GW - 283

**Southern Union Gas Services
Jal South Compressor Station
GW-283**

INSPECTIONS FROM GU-283 PERMIT CONDITIONS

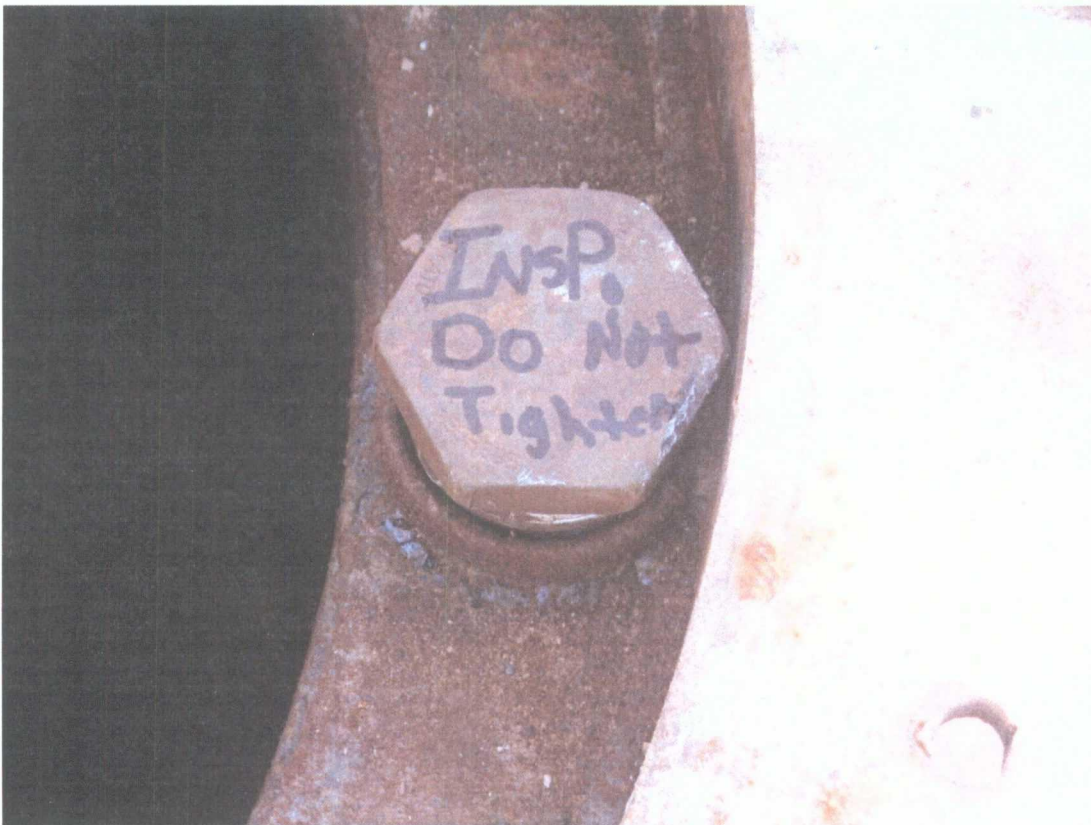
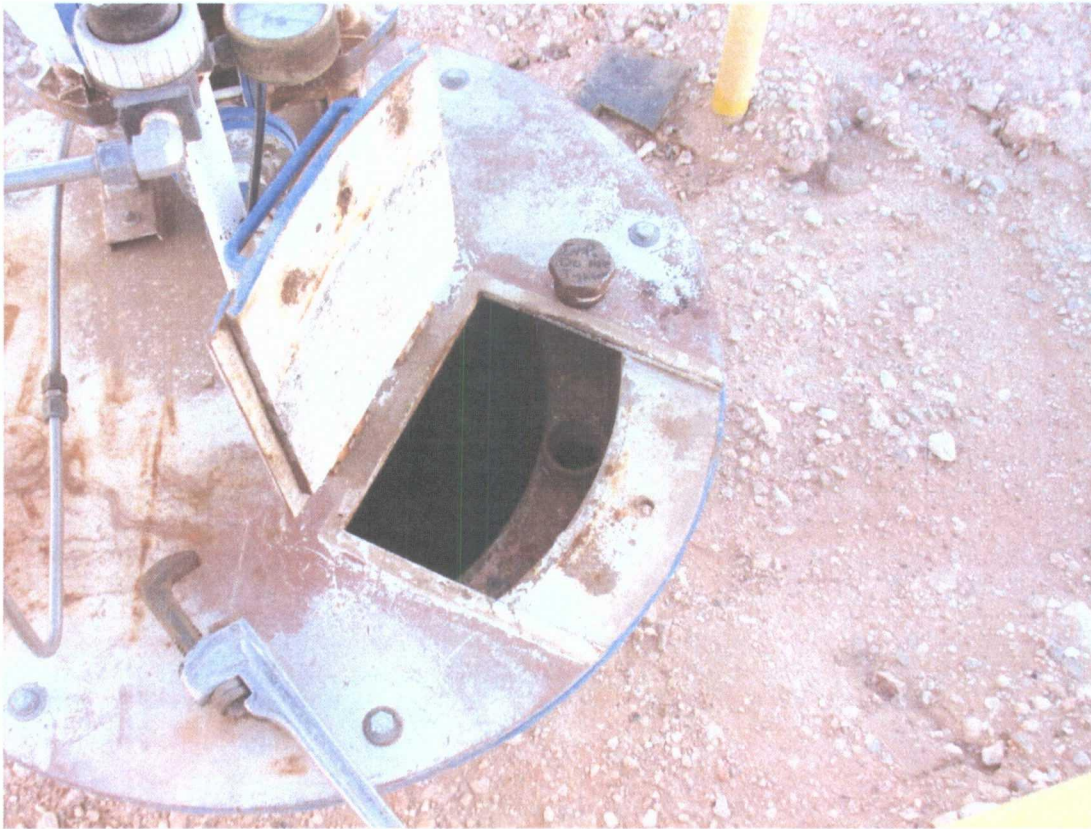
OCD * **STILL OPEN:** The OCD requested inspection records for this sump and all other sumps on at this facility please provide. The OCD considers this an unresolved item.

OCD * **STILL OPEN:** still open until the OCD receives and reviews facility diagram.

OCD * **STILL OPEN:**

The OCD will wait until it receives the facility diagram identifying the drain ports and lines to close concerns for Photo 5.

Where were the tar/roskote substances taken to?

Please provide the OCD an update on the results of the soil beneath the floor and the status of the crack work and rhino spray.

The plug was loosened and labeled hand tighten, inspection plug.

The sump total outside dimensions are 3 ft. diameter by 13 ft. in depth. The inner sump dimensions are approximately 2 inches less than that allowing for an air space between the outer and inner walls.

There was a foreman plug in the drain port beneath the sand and debris that had accumulated in the containment. This drain port is common with all of the other drain lines that were tested in 2008. SUGS will send a facility diagram identifying the drain ports and lines.

The containment area was cleaned on 10/7/08. During the cleaning event it was discovered that the concrete containment bottom and sides were coated with a tar/roskote substance that had started flaking and coming loose in several locations. All of the material was removed and placed in plastic bags, samples were taken to make sure the material does not contain asbestos. Pending the results of the analytical, the material will be properly disposed of. Also during the cleaning event several cracks were discovered in the floor and sides of the concrete containment. We had a RPE calculate the tank volumes and containment capacity to make sure that the containment capacity was sufficient, his assessment is attached. Our plan is to determine if the area beneath the floor of the containment has been impacted by drilling holes in the floor and testing the soil beneath the floor. If the tests are negative we will plug the holes, remove the waste water and condensate tanks, thoroughly clean the area and spray a rhino lining on the concrete. Bids have already gone out to contractors to perform the necessary work.
